Re: Turkey Point Units 3 and 4
Docket Nos. 50-250 and 50-251
Alternative Examination Requirements of RPV Nozzle-to-Vessel Welds
Relief Request No. 23

Relief Request No. 23
Alternative Examination Requirements of RPV Nozzle-to-Vessel Welds

FIG. 1 NOZZLE IN SHELL OR HEAD
 (Examination Zones in Barrel Type Nozzles Joined by Full Penetration Corner Welds)

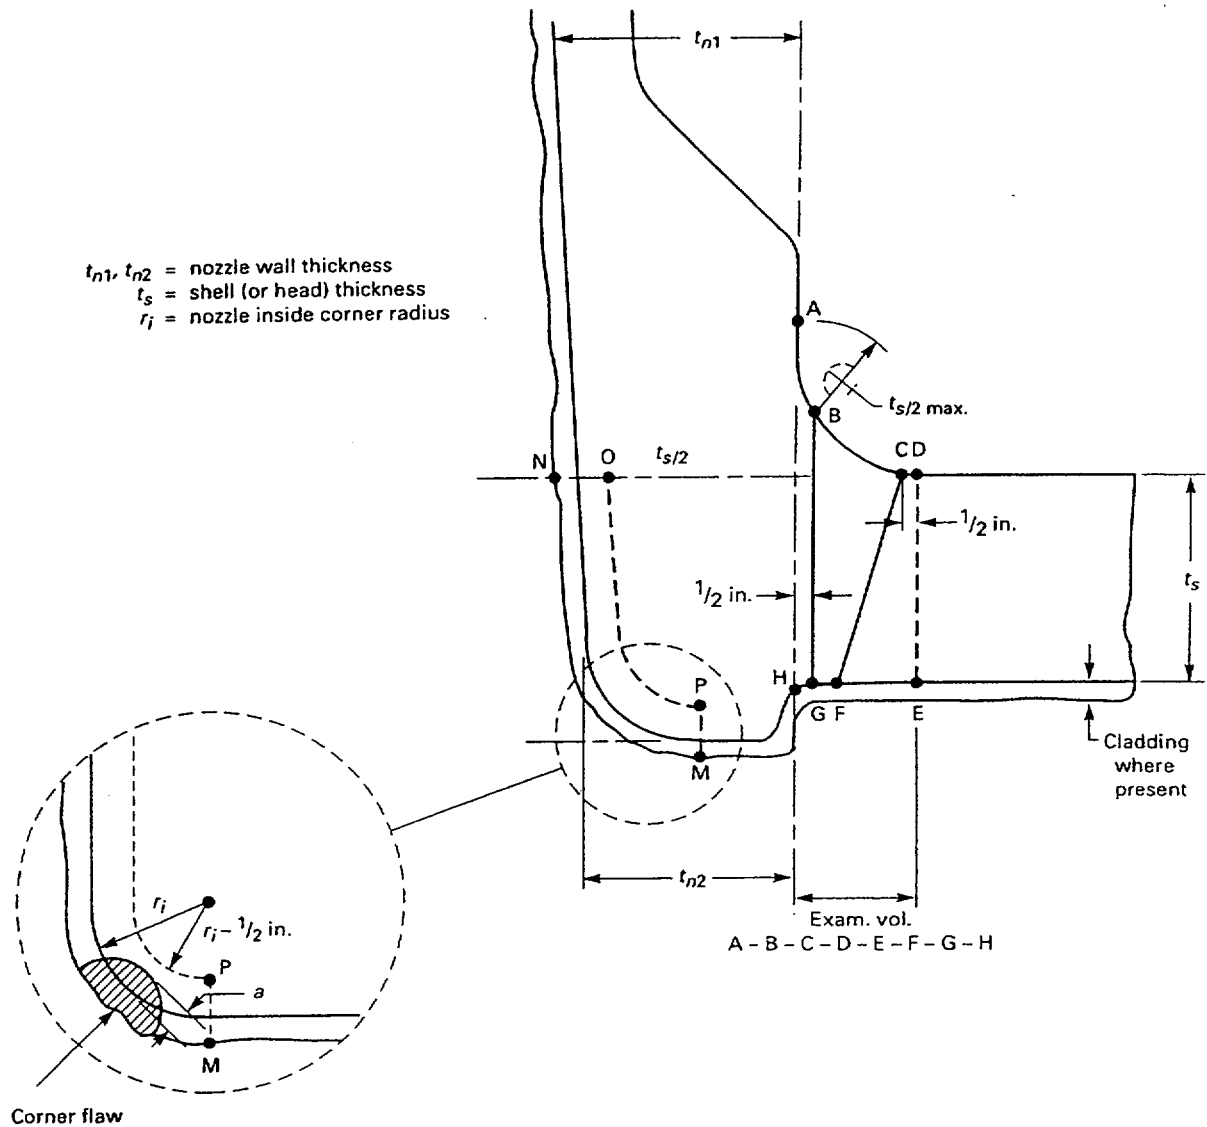
The attached figures reduce the examination volume next to the widest part of the weld from half of the vessel wall thickness to one-half (1/2) inch. This removes examination from the base metal that was extensively examined during construction and pre-service inspection and is not in the high residual stress region associated with the weld. These high-stressed areas are contained in the volume that is defined by the attached figures and are subject to examination.

1. Perform examinations in accordance with the exam volume as defined in Figures 1 and 2.
2. Conduct Mechanized Ultrasonic Examinations of essentially 100% of all welds using Performance Demonstration Initiative (PDI) ASME Section XI, Appendix VIII qualified procedures and personnel. This will be accomplished in accordance with ASME Code, Section XI, Division 1, 1995 Edition, 1996 Addenda, Appendix VIII, Supplement 7 as modified by 10CFR50.55a.
3. Periodic System Pressure Tests per Category B-P, Table IWB-2500-1
